GEOTECHNICAL AND GEOLOGIC HAZARD INVESTIGATION
The Ridge Nests Development
Powder Mountain Resort
Weber and Cache Counties, Utah

IGES Project No. 01628-008

Subject: Response to Review Comments
Geotechnical Investigation
The Ridge Nests Development
Powder Mountain Resort
Weber and Cache Counties, Utah

Subject: Response to Review Comments - Geology
Geotechnical Investigation
The Ridge Nests Development
Powder Mountain Resort
Weber and Cache Counties, Utah

Figure 1 – Geologic Cross-Sections

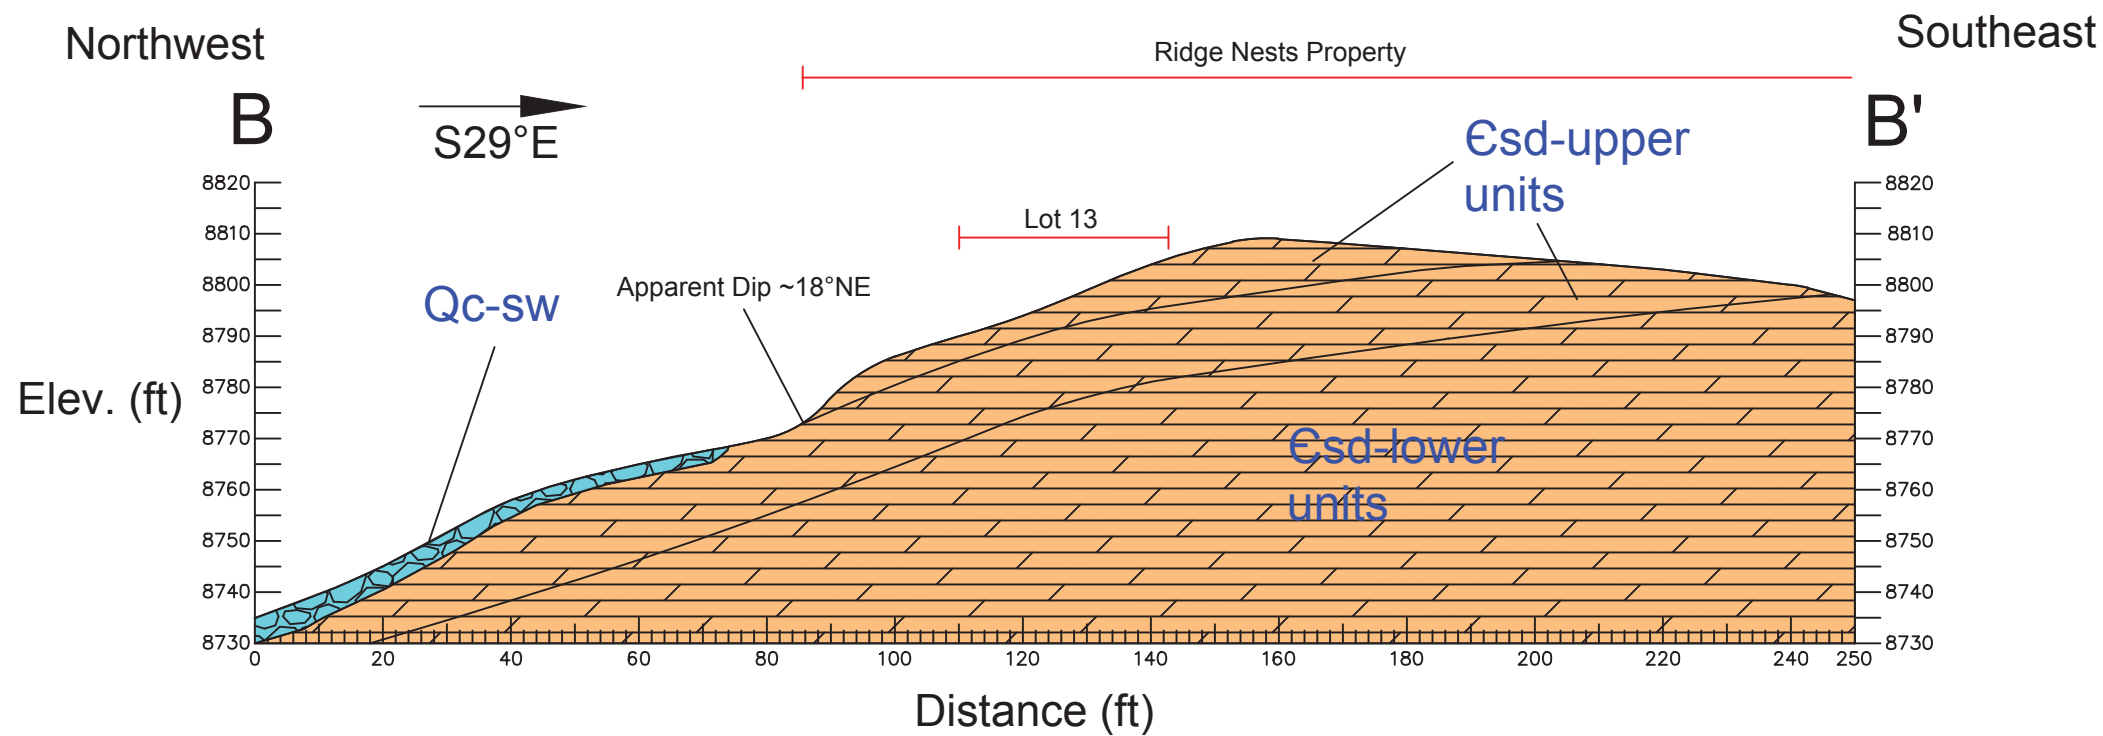
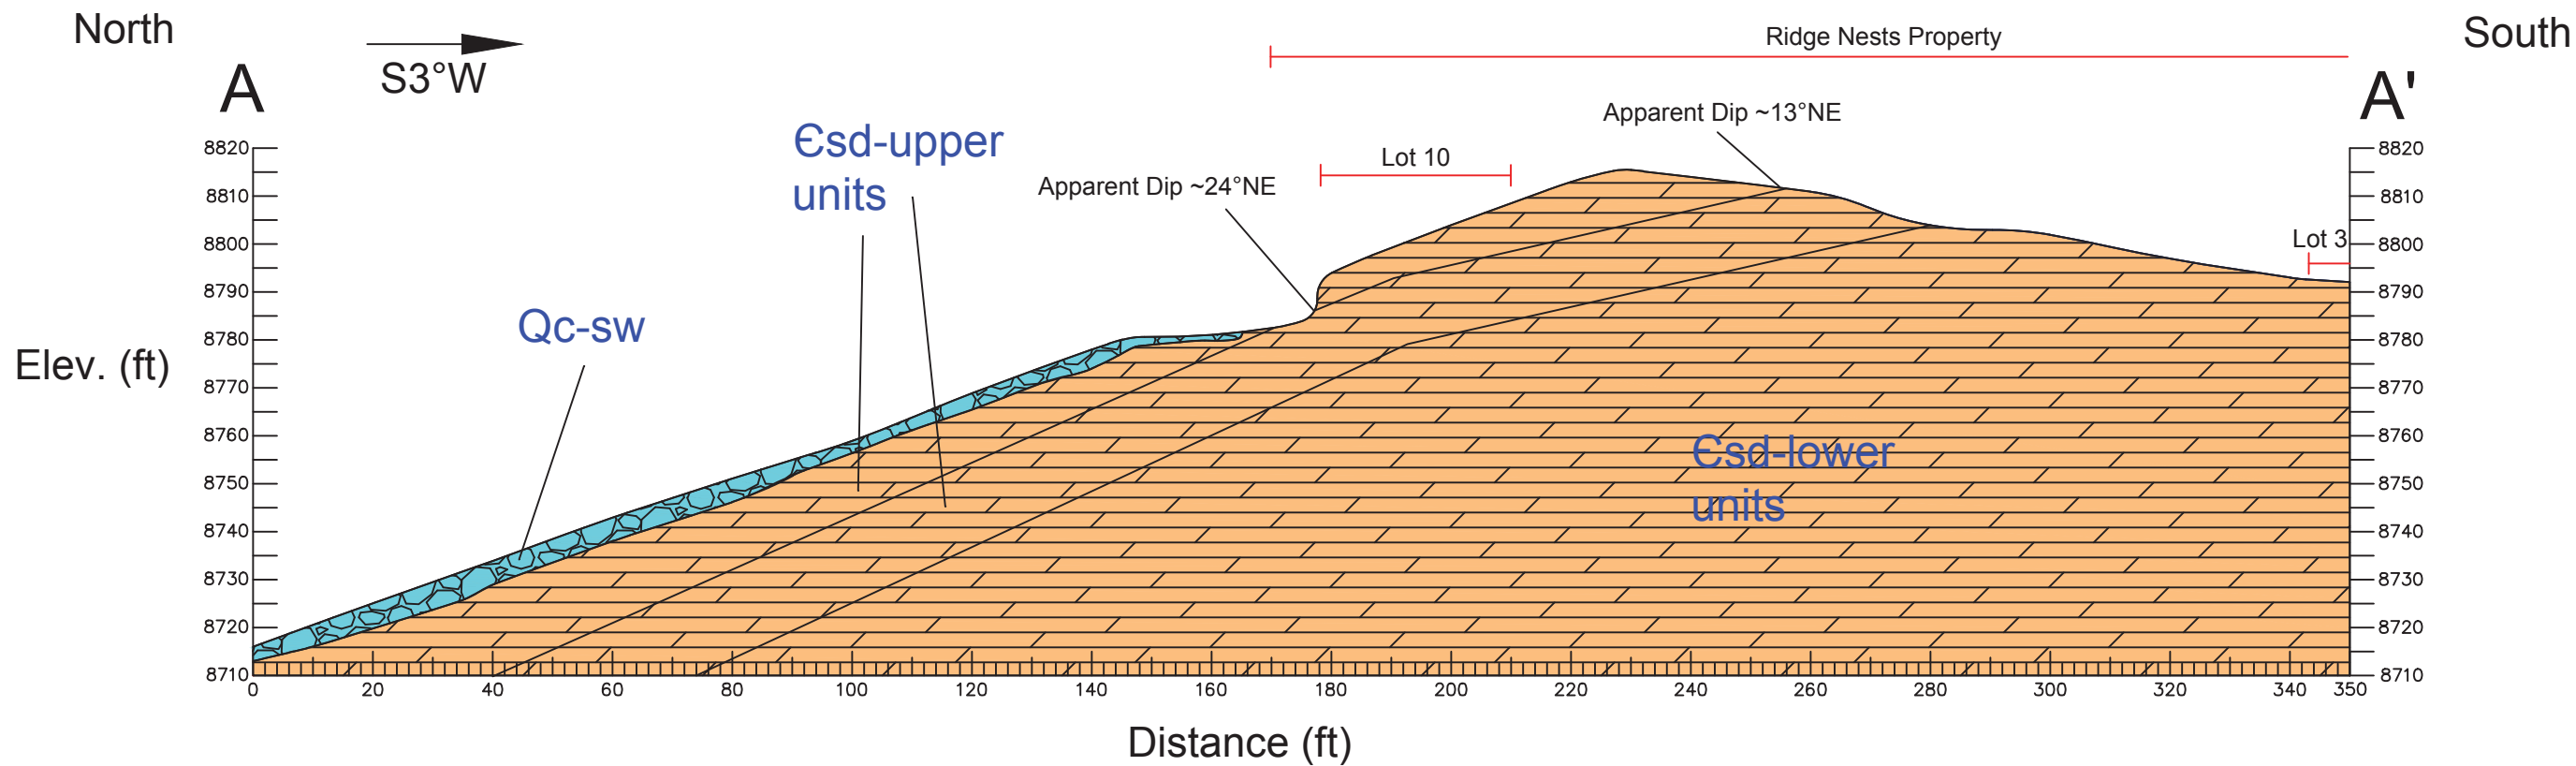
“Figure A-2, Geotechnical Map, of the September 16, 2014 IGES report depicts “...the relative locations of the various geologic units...” described in the September 16, 2014, IGES report. SA recommends Weber County request IGES:

A geologic investigation of Lot 13 and the immediate area surrounding the Ridge Nests subdivision was conducted by an IGES engineering geologist between August 26 and 27, 2015. Plate 1 (*Geologic Map*) is an updated, expanded version of the original Figure A-2, *Geotechnical Map*, from the IGES geotechnical report. The geologic mapping has been extended to several hundred feet in all directions from the original map, and minor modifications to the original geologic contacts have been made based upon the findings of the investigation. Additionally, bedding and jointing attitudes, and the approximate locations and orientations of identified faults are presented on the map. Two geologic cross-sections providing a representative picture of the subsurface of the property are illustrated on Figure 1. A brief description of the findings of the geologic investigation follows.

Based on the geologic evidence presented on the attached *Geologic Map* (Plate 1) and the associated geologic cross-sections, and the slope stability assessment presented herein, the following conclusions are made:
